Addendum #2
Solicitation # 20-10AA
Hot Water Distribution System Balance of Plant (Mechanical) at Duluth Energy Systems

This addendum serves to notify all bidders of the following changes to the solicitation documents:

BORING NUMBER SB-19-1

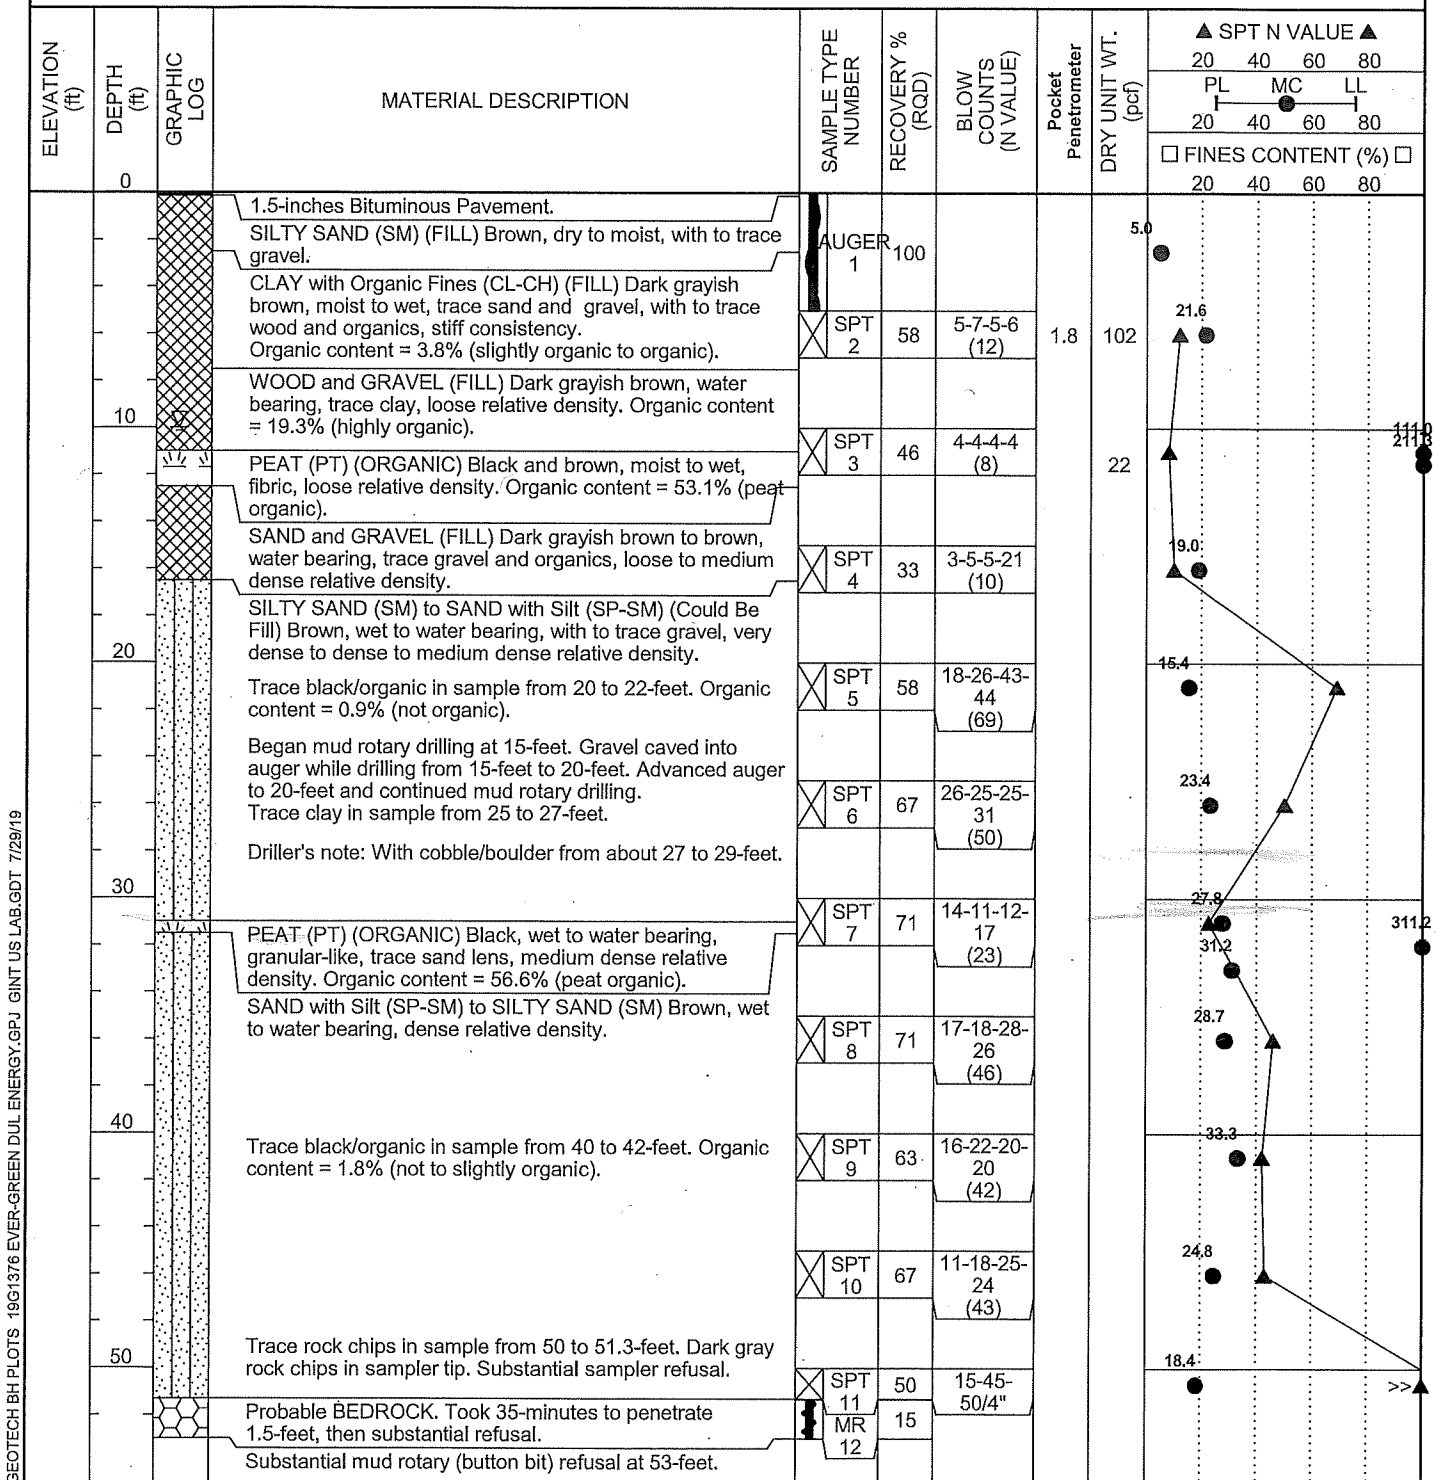
"I am looking for some help locating the geotechnical report for this project which is referenced on sheet S204 under plan notes No. 2. American Engineering Testing (AET) Report No. 01-20551. Specifically, I am looking for the soil log for SB-19-1. Any help here would be greatly appreciated."

Response: The requested report has been included with this addendum for bidders' use.
